Lower Thames Crossing

9.104 Final Agreed Statement of Common Ground between (1) National Highways and (2) The Master, Fellows and Scholars of the College of Saint John the Evangelist in the University of Cambridge (Clean version)

Planning Inspectorate Scheme Ref: TR010032
Examination Document Ref: TR010032/EXAM/9.104

Appendix B SJC Alternative Design

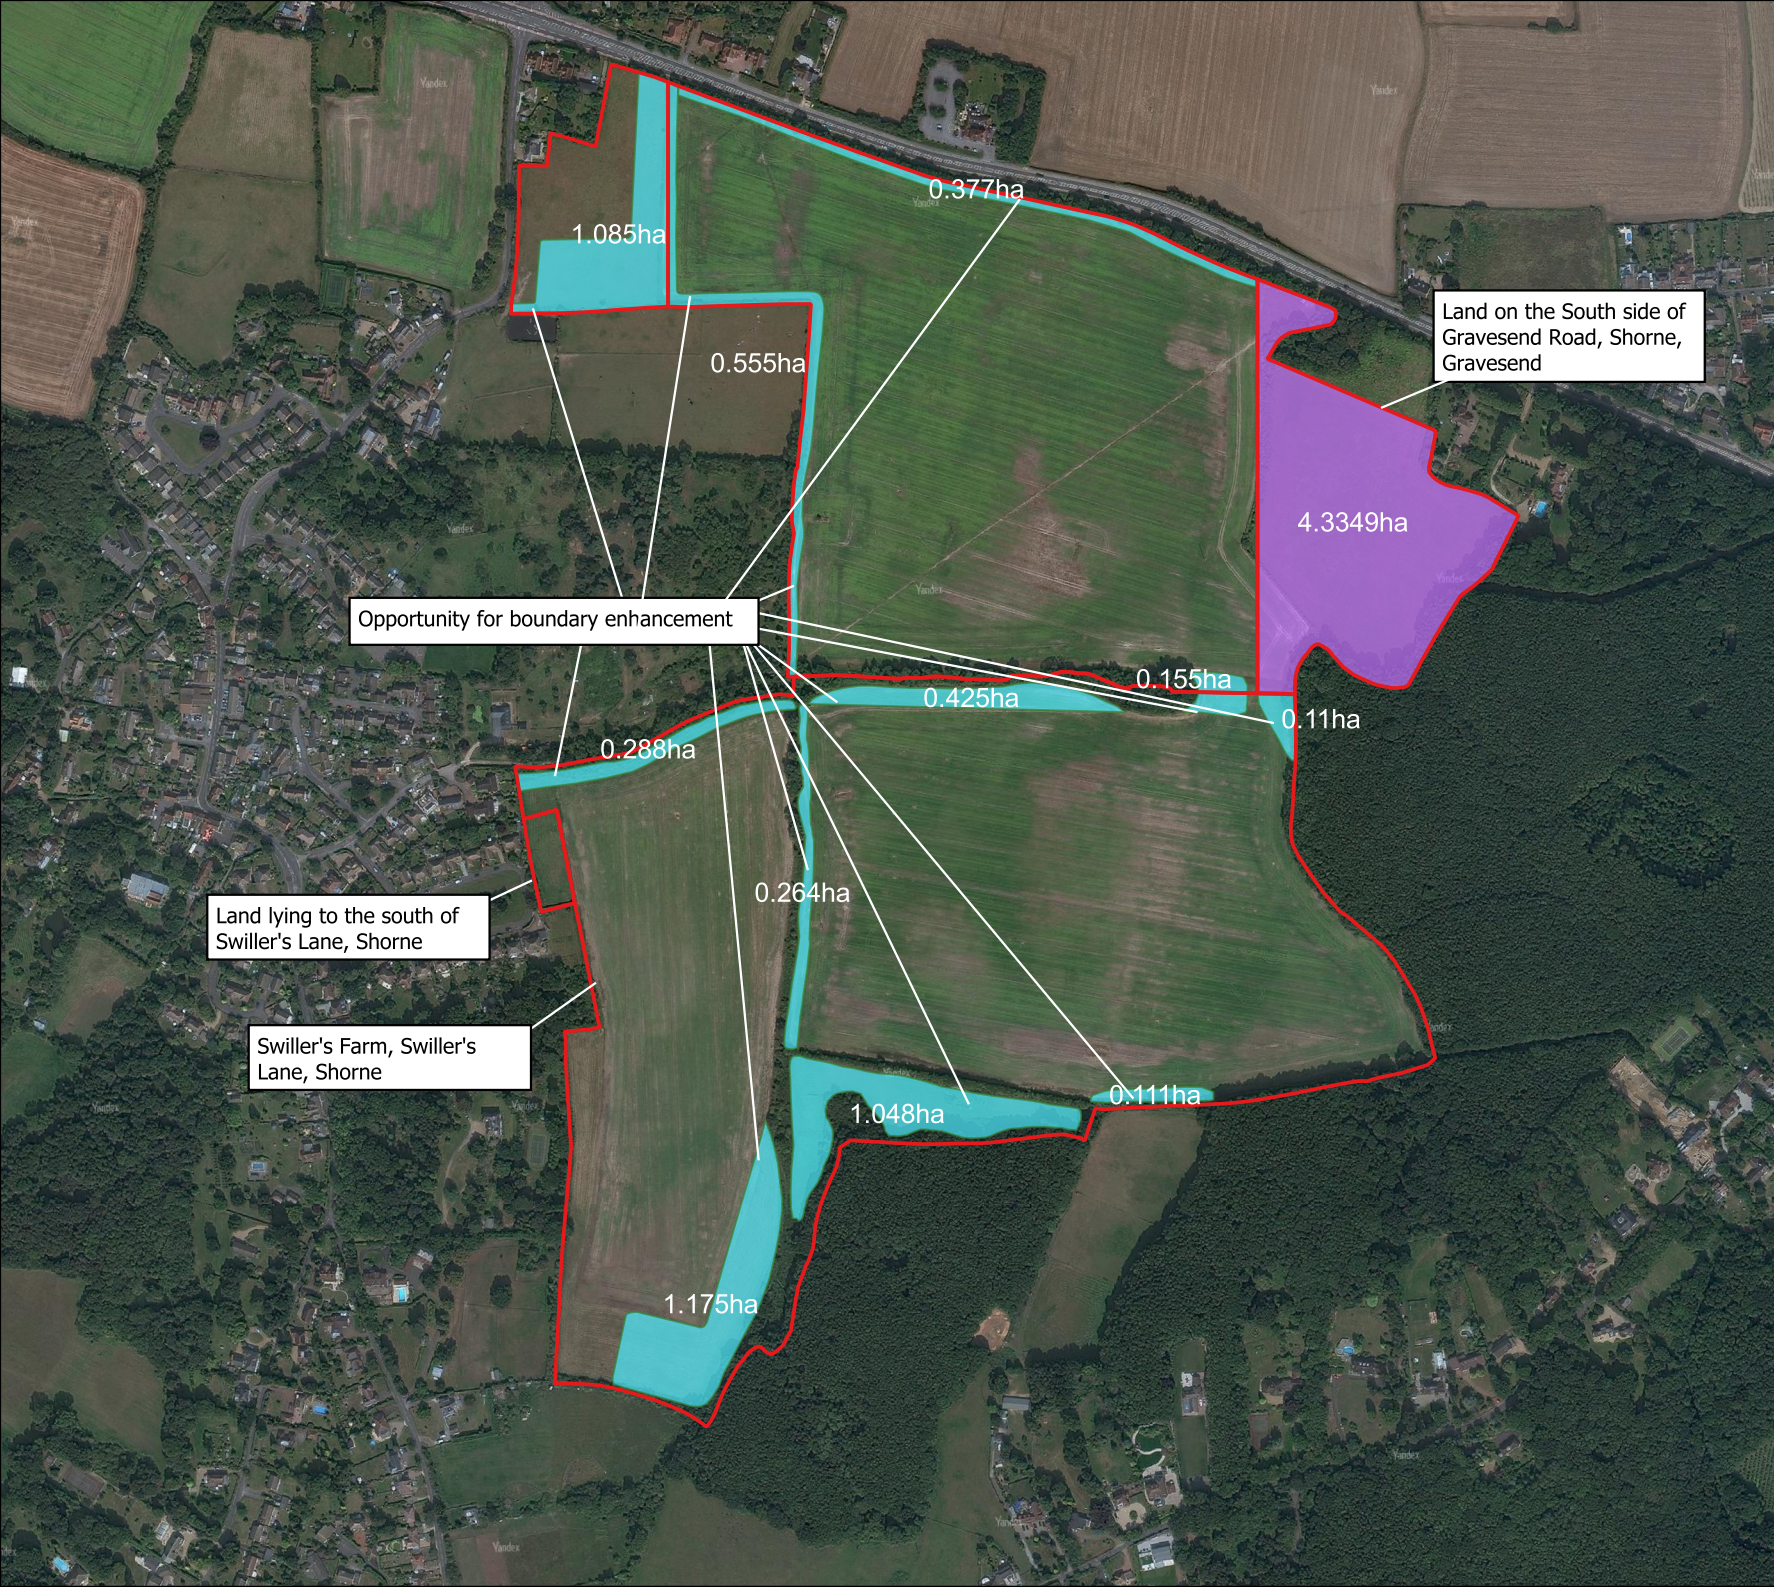
Alternative design	2.1.7	SJC suggest an alternative way of managing the land going forwards that a) achieves the habitat connectivity that the Applicant is seeking, b) reduces nitrogen	The alternative approach suggested by SJC would not achieve the necessary	N/A	Matter Not Agreed

Topic	Item No.	SJC Comment	The Applicant’s Response	Application Document Reference	Status
		<p>inputs to the land and c) retains Grade 2 farmland in sustainable production in the future.</p> <p>This has been focused on land within SJC’s ownership, although we note from, aerial photography, that there are other smaller, less viable fields for agriculture, that look at least as suitable for these purposes in the surrounding area to both the north and the south of the route.</p> <p>In essence, SJC’s proposals are to plant, close gaps and strengthen hedgerows, provide regenerative field margins to improve biodiversity and habitat corridors, and to reduce artificial fertiliser inputs to this land through regenerative farming techniques. This will improve the soil structure and retain it for future generations, contributing to food security. Please refer to the plan appended in Appendix B.</p> <p>SJC notes there is a desire to plant 70% of the land with trees, and would suggest that this should not be done on prime agricultural land if there is a reasonable alternative.</p> <p>SJC’s alternative proposal was a draft for discussion and SJC remained open to dialogue to agree what corridor widths were necessary to achieve connectivity, having based these on LTC’s own design for</p>	<p>objectives of the nitrogen deposition compensation.</p> <p>In particular, the alternative proposal suggested would not achieve sufficient additional ecological connectivity within the ecological network that affected sites lie within, whilst meeting the twin objective of enabling the creation of a comparable area of compensation across the project in response to the existing areas of habitat that would be significantly affected.</p> <p>The site selection methodology is set out in the PAQAP, and is supported by NE at deadline 8 [REP8-154] which identifies the constraints and opportunities considered in selecting the sites.</p>
